H. B. ROBINSON STEAM ELECTRIC PLANT, UNIT NO.
DOCKET NO. 50-261
LICENSE NO. DPR-23

ENVIRONMENTAL QUALIFICATION OF SAFETY-RELATED
ELECTRICAL EQUIPMENT

RESPONSE TO THE NRC ENVIRONMENTAL QUALIFICATION OF SAFETY-RELATED
ELECTRICAL EQUIPMENT - SAFETY EVALUATION REPORT BY THE OFFICE OF
NUCLEAR REACTOR REGULATION EQUIPMENT QUALIFICATION BRANCH FOR
CAROLINA POWER & LIGHT COMPANY H. B. ROBINSON UNIT 2.

FIGURE 14.3.4-4

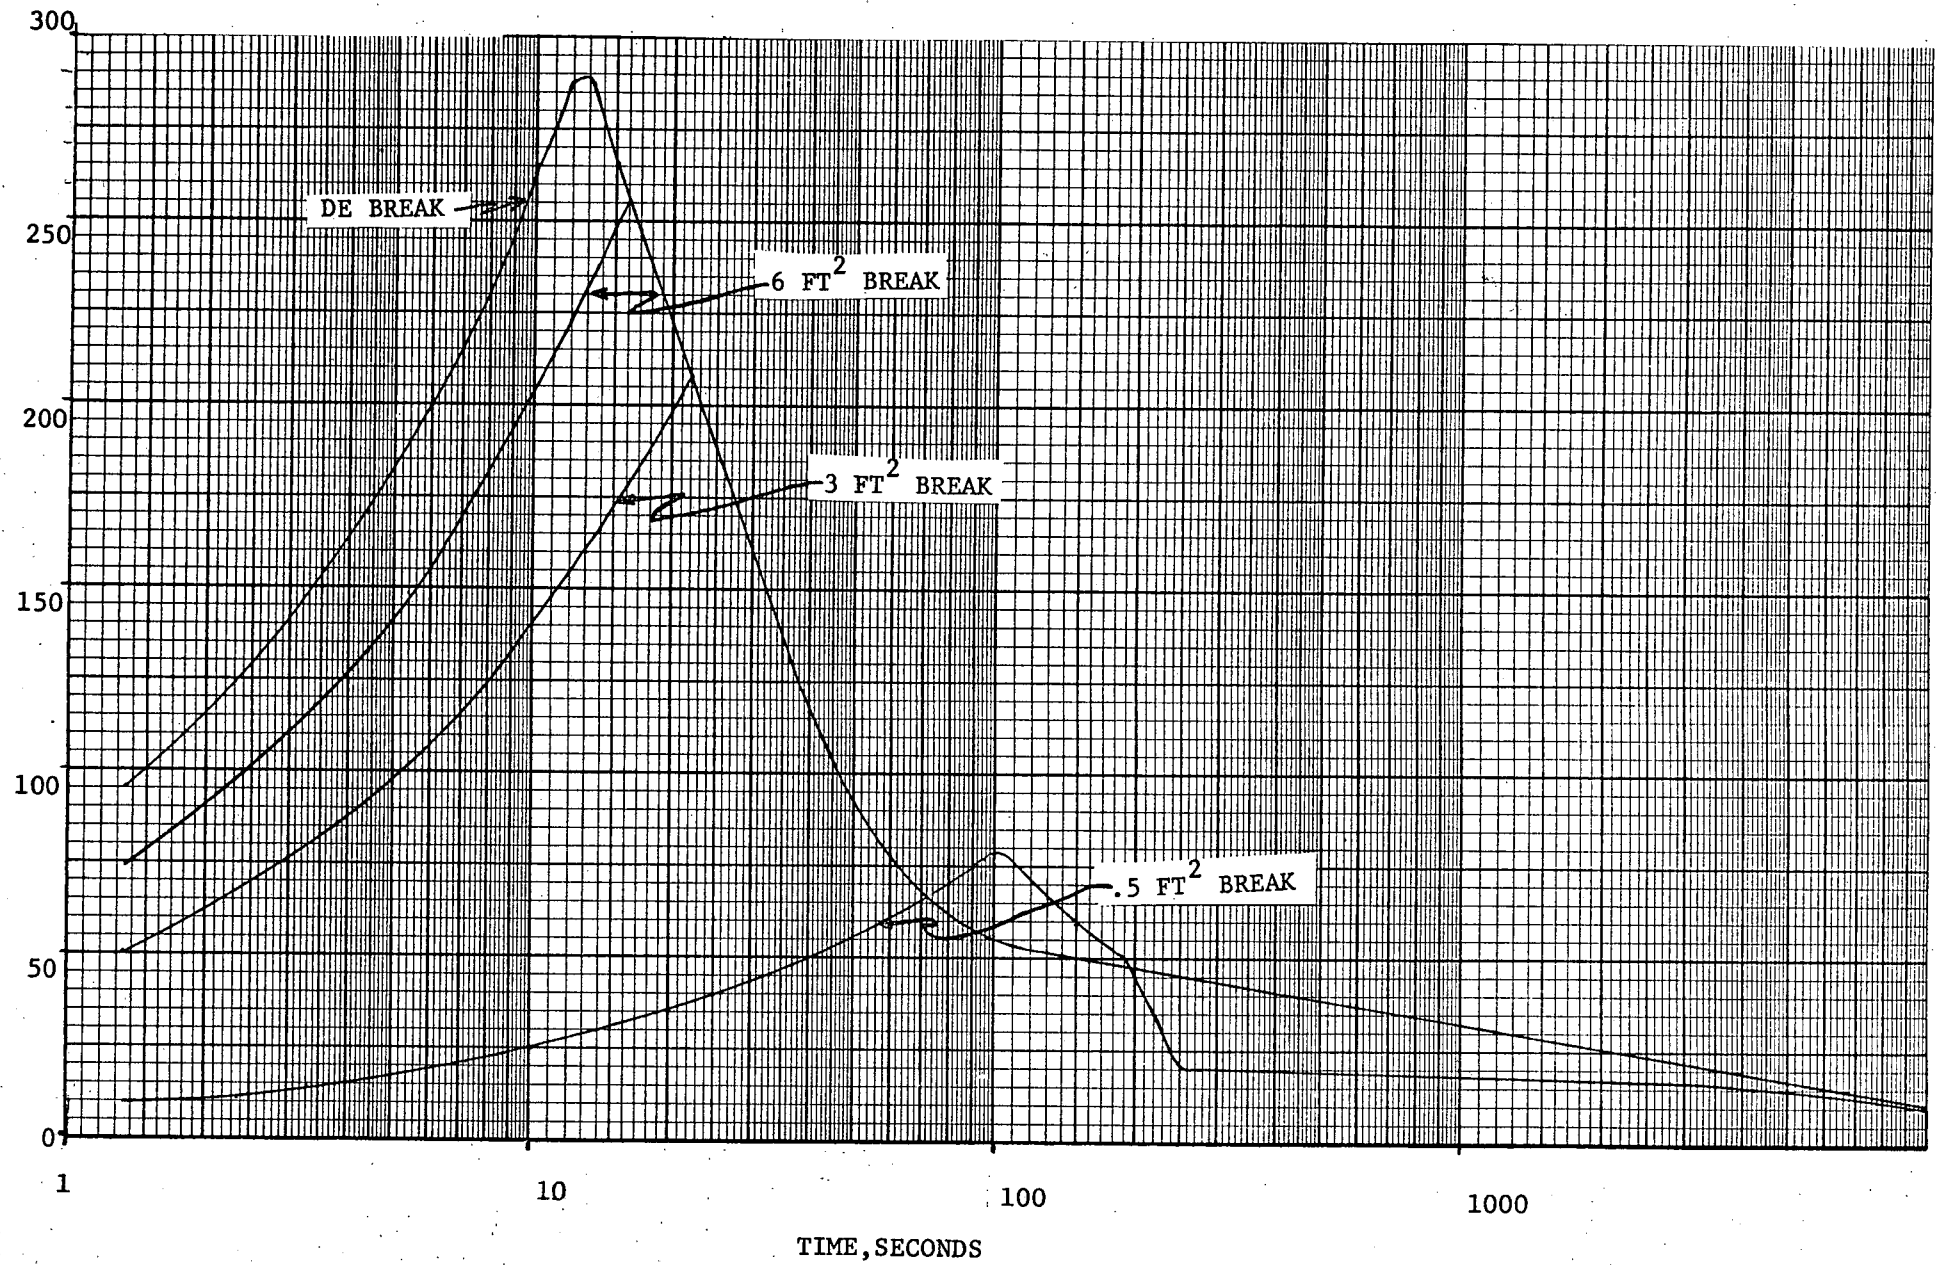
Of further note, the H. B. Robinson calculated maximum pressure associated with a double-ended break is 38 psig (peaking at 12 seconds after LOCA and reducing to 32 psig after 3000 seconds). The stated 42 psig within our IE Bulletin 79-01B responses refers to the containment design pressure; therefore, a margin of approximately 11% above the conservative value of the blowdown peaks is available. H. B. Robinson Unit 2 FSAR, Section 14.3.4, Containment Integrity Evaluation, contains data and parameters associated with containment pressure. See Figure 14.3.4-2, Containment Pressure Transients for a Range of Break Sizes, Figure 14.3.4-4, Structural Heat Transfer Coefficient, and Figure 14.2.4-6, Containment Capability Study, All Available Energy for graphic presentation of H. B. Robinson LOCA profiles.

Per the above, we do not believe it is justified to recalculate the LOCA pressure and temperature profiles. The conservatism involved with the values and the tested values for equipment as recorded on the System Component Evaluation Work Sheets indicate there are no conflicting or questionable pressure and/or temperature values involved.
